ND-2011-0011
March 21, 2011

Subject: **PSEG Early Site Permit Application**
Docket No. 52-043
Response to Request for Additional Information, RAI No. 9, Site
Location and Description

**ENCLOSURE 2
Proposed Revisions
Part 2 – Site Safety Analysis Report (SSAR)**

Site Utilization Plan
FIGURE 1.2-3 Rev.0

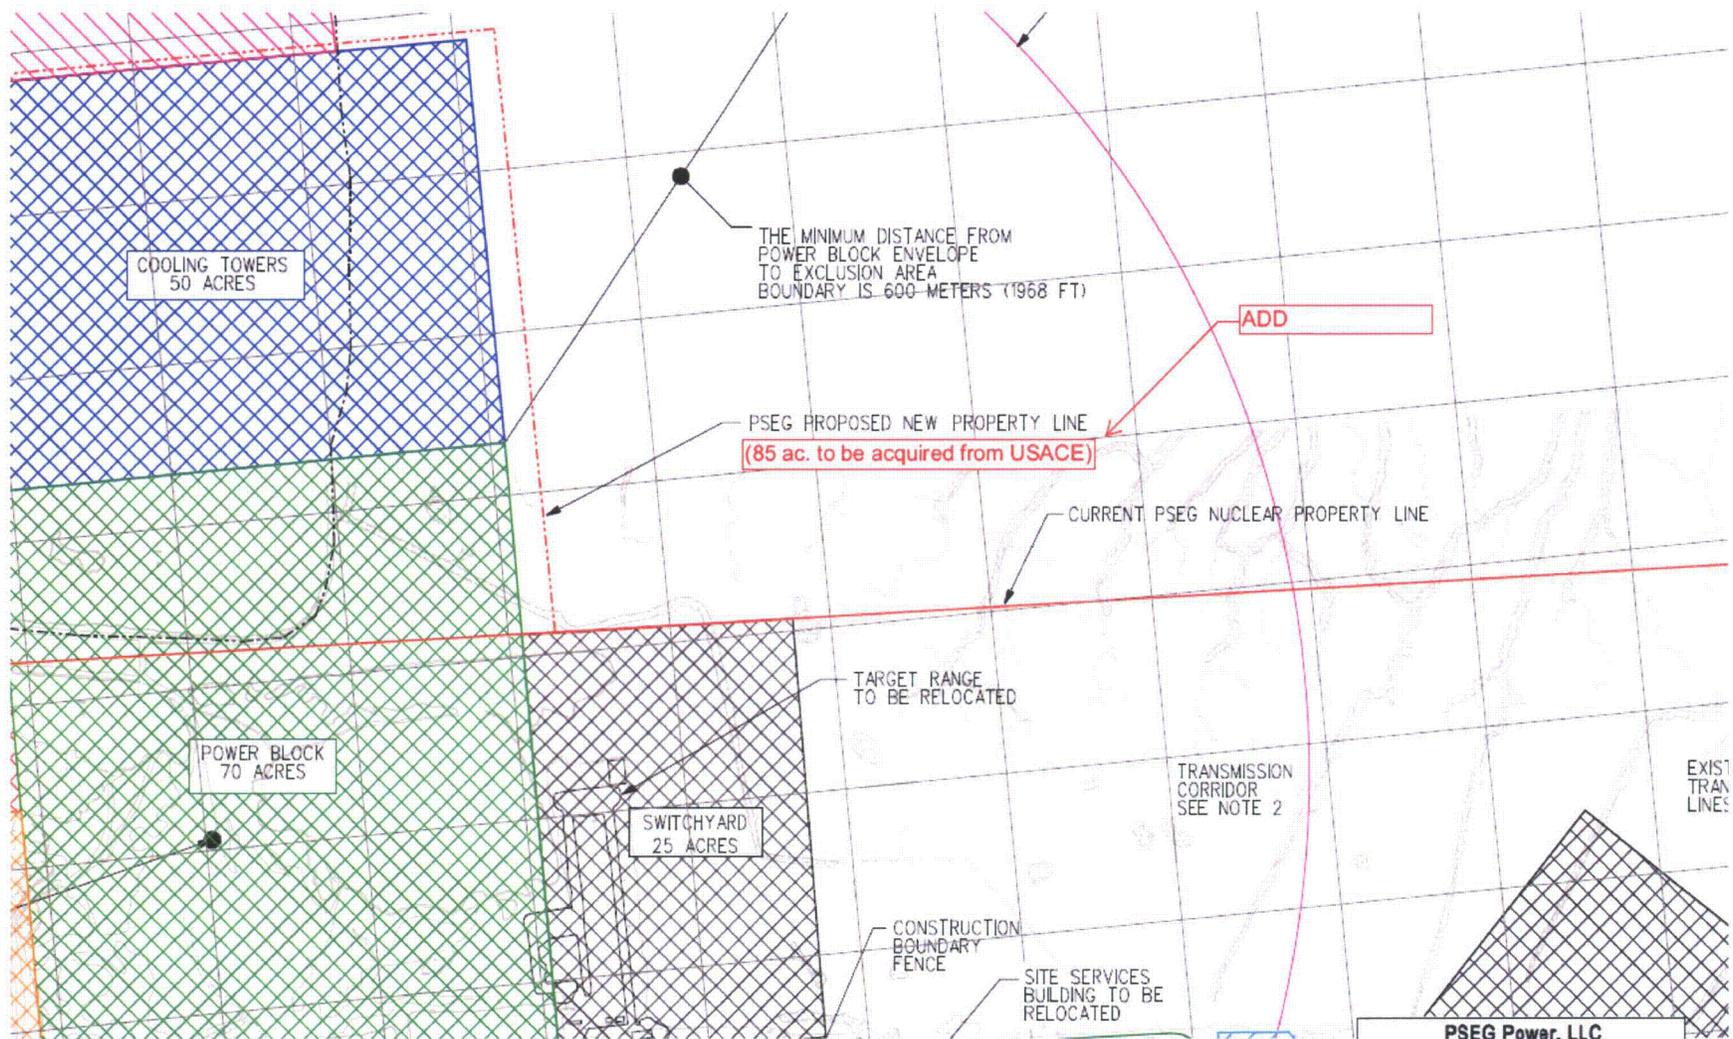
Based on the Latitude and Longitude coordinates also provided in Subsection 2.1.1.2 and on Figure 1.2-3, the UTM coordinates appear to be in feet. The Staff notes that hardcopy USGS 7.5-minute quadrangle topographical maps typically show UTM Northing and Easting coordinates in meters.

To avoid confusion, the Applicant should annotate the list of UTM coordinates in SSAR Subsection 2.1.1.2 (Paragraph 2) and in the marginal notes on SSAR Figure 1.2-3 with the correct units of measure. The Applicant should also confirm whether any other text, tables, or figures in the SSAR specify these UTM coordinates without indicating the corresponding units of measure and, if so, update accordingly.

It appears from SSAR Figure 1.2-3 that this additional 85 acres of land is bounded by the area labeled as "PSEG Proposed New Property Line". To make a distinction among these different areas within the EAB, the Applicant should confirm whether the 85-acre parcel of land is, in fact, bounded by the labeled area as indicated above. If so, clarify the associated text under SSAR Section 2.1 and/or Figure 1.2-3 accordingly. If not the case, update SSAR Section 2.1 and Figure 1.2-3 as necessary.

The Universal Transverse Mercator (UTM) coordinates described in Subsection 2.1.1.2 (Paragraph 2) and Figure 1.2-3 of the Site Safety Analysis Report (SSAR) have units of measure in feet. The remainder of the SSAR was searched and UTM coordinates are not presented in any other text, table or figure.

The SSAR text in Subsection 2.1.1.2 and Figure 1.2-3 will be annotated to note the units of measure. Enclosure 2 provides the markup of the proposed revision. SSAR Figure 1.2-3 is also used in Environmental Report (ER) Figure 3.1-2. The markup contained in Enclosure 2 will also be applied to ER Figure 3.1-2.

The additional 85 acres immediately to the north of the existing site property is the area of land bounded by the area labeled as "PSEG Proposed New Property Line" on Figure 1.2-3.

The SSAR text in Subsection 2.1.1.1 and Figure 1.2-3 will be revised to clarify the 85 acres of land to be acquired from the USACE. Enclosure 2 provides the markup of the proposed revision. SSAR Figure 1.2-3 is also used in Environmental Report Figure 3.1-2. The markup contained in Enclosure 2 will also be applied to ER Figure 3.1-2.

ADD

ADD
